Access Compliance Report

Public Rights-of-Way

(Pedestrian Signals)

Intersection ID: N/A	Main Street:	Cross Street: N/A	Location: N/A
ADA ID: 118F97C2B8AD	Signal Type: Two Push Buttons-APS	Overall Compliance: No	Severity Score: BTN 1:N/A BTN 2: N/A No BTN: N/A
Codes/Mitigation Info/Possible Solution		Field Measurements/Component Compliance

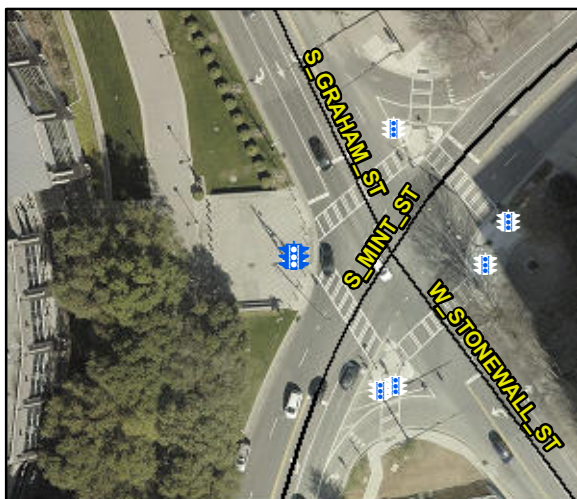
Surveyor Notes: TEXT HT 1/4

PROW/ADA: R410.6, TMUTCD 4e.08, R404.2, R406.2,

Compliance	Description	Data	Compliance	Description	Data
	Button Count	Button2	N/A	Distant to Additional Button (in)	N/A
	Additional Button Present?	N/A		Additional Button ID	N/A
N/A	Signal Buttons Required?	N/A	N/A	Additional Ped Posts Required	N/A
	How Many Ped Street Xings?	2		Located In An Island/Median?	No
N/A	B 1 Sign Present?	Yes	N/A	B 2 Sign Present?	Yes
Yes	B 1 Sign Purpose?	Yes	Yes	B 2 Sign Purpose?	Yes
No	B 1 Sign Lettering & Contrast?	No	No	B 2 Sign Lettering & Contrast?	No
Yes	B 1 Parallel To XWalk?	Yes	Yes	B 2 Parallel To XWalk?	Yes
Yes	B 1 PAR to Button?	Yes	Yes	B 2 PAR to Button?	Yes
Yes	B 1 PAR to XWalk?	Yes	Yes	B 2 PAR to XWalk?	Yes
Yes	B 1 Clear Floor Space?	Yes	Yes	B 2 Clear Floor Space?	Yes
N/A	B 1 FWD Approach?	Yes	N/A	B 2 FWD Approach?	Yes
N/A	B 1 FWD Approach Constrained?	No	N/A	B 2 FWD Approach Constrained?	No
No	B 1 FWD Approach Reach (in)	2.0	No	B 2 FWD Approach Reach (in)	3.0

N/A	B 1 FWD Approach Width (in)	N/A	N/A	B 2 FWD Approach Width (in)	N/A
N/A	B 1 FWD Approach Obstruction?	Yes	N/A	B 2 FWD Approach Obstruction?	Yes
N/A	B 1 FWD Approach Obstruction Dist (in)	2.0	N/A	B 2 FWD Approach ObstructionDist (in)	3.0
N/A	B 1 PARA Approach?	Yes	N/A	B 2 PARA Approach?	Yes
N/A	B 1 PARA Approach Constrained?	No	N/A	B 2 PARA Approach Constrained?	No
Yes	B 1 PARA Approach Reach (in)	2.0	Yes	B 2 PARA Approach Reach (in)	3.0
N/A	B 1 PARA Approach Width (in)	N/A	N/A	B 2 PARA Approach Width (in)	N/A
N/A	B 1 PARA Approach Obstruction?	Yes	N/A	B 2 PARA Approach Obstruction?	Yes
N/A	B 1 PARA Approach Obstruction Dist (in)	2.0	N/A	B 2 PARA Approach ObstructionDist (in)	3.0
Yes	B 1 Clear Floor Space Slope (%)	0.2	Yes	B 2 Clear Floor Space Slope (%)	1.5
No	B 1 Clear Floor Space XSlope (%)	3.1	Yes	B 2 Clear Floor Space XSlope (%)	1.9
N/A	B 1 PAR Slope (%)	1.8	N/A	B 2 PAR Slope (%)	0.6
Yes	B 1 Height (in)	36.0	Yes	B 2 Height (in)	36.0

Yes	B 1 Clear Xing Direction?	ClearlyMarked	Yes	B 2 Clear Xing Direction?	ClearlyMarked
	B 1 Crossing Direction	To SE		B 2 Crossing Direction	To NE
No	B 1 DistanceTo XWalk (in)	102.0	Yes	B 2 DistanceTo XWalk (in)	0.0
No	B 1 DistanceTo Curb (in)	208.0	No	B 2 DistanceTo Curb (in)	215.0
Yes	B 1 Diameter (in)	2.0	Yes	B 2 Diameter (in)	2.0

Possible Solutions: Replace Signal Push Button With APS Button on New Post. Remove & Replace Sign.
